Work Order ID 50618

Item Name: Basket Hoop

DESIGN #	DRAWN BY CP	DART AEROSPACE LTD HAWKESBURY, ONTARIO, CANADA	
CHECKED #	APPROVED #	DRAWING NO. D3166	REV. A SHEET 1 OF 1
DATE 02.07.10		TITLE BASKET HOOP	SCALE NTS
A	02.07.10	NEW ISSUE	
A1	04.04.08	384/-1 WTS 36.0

DRAWING NO. D3166	TITLE BASKET HOOP	REV A1	DART AEROSPACE LTD ENGINEERING ORDER		D.E.O. NO. D3166-A-2	SHEET NO. 1 OF 1	SCALE NTS
DRAWN AJS	CHECKED [Signature]	MFG. APPR. [Signature]	APPROVED [Signature]		DE APPR. [Signature]		
DATE 08.12.11	DATE 08.12.15	DATE 08/12/15	DATE 08/12/16		DATE 08.12.16

D3166-1 BASKET HOOP

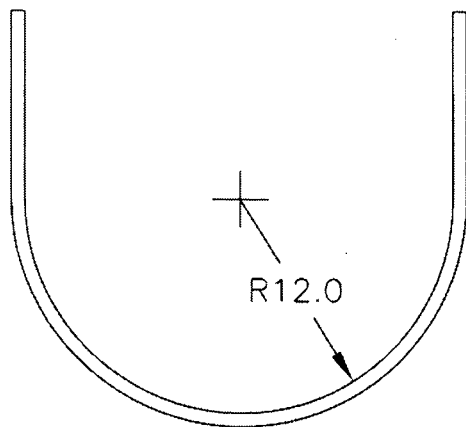
1) MODIFY MATERIAL NOTE FOR D3166-1 AS SHOWN:

WAS:

1) MATERIAL: AISI 304/316 SS SQUARE TUBING,
0.75" x 0.75" x 0.063 WALL, 60.00" LONG
(REF DART SPEC. M304TS0.750W.063)

IS:

1) MATERIAL: AISI 304/316 SS, 3/4 X 3/4 X 0.065 WALL SQUARE TUBING,
60.00" LONG
REF. DART SPEC M304TS0.750W.065

D3166-3 BASKET HOOP

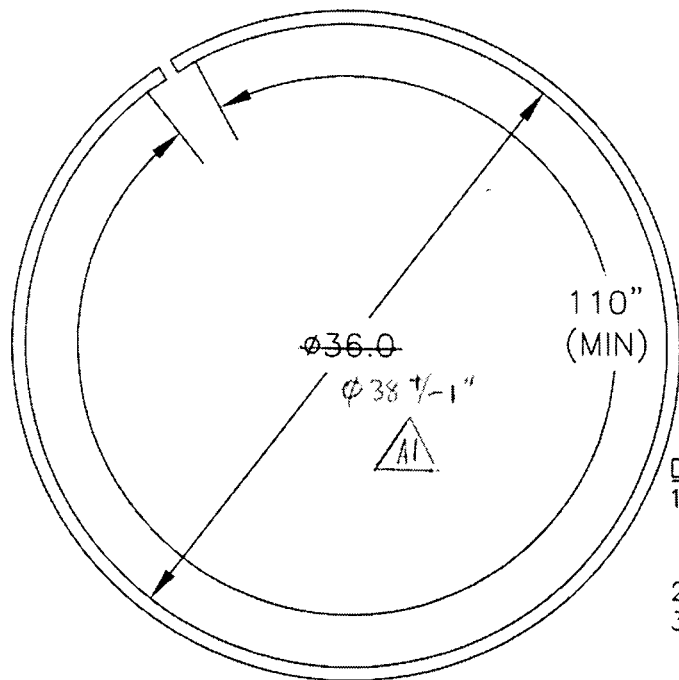
2) MODIFY MATERIAL NOTE FOR D3166-3 AS SHOWN:

WAS:

1) MATERIAL: AISI 304/316 SS SQUARE TUBING,
0.75" x 0.75" x 0.063 WALL, 120.00" LONG
(REF DART SPEC. M304TS0.750W.063)

IS:

1) MATERIAL: AISI 304/316 SS, 3/4 X 3/4 X 0.065 WALL SQUARE TUBING,
120.00" LONG
REF. DART SPEC M304TS0.750W.065
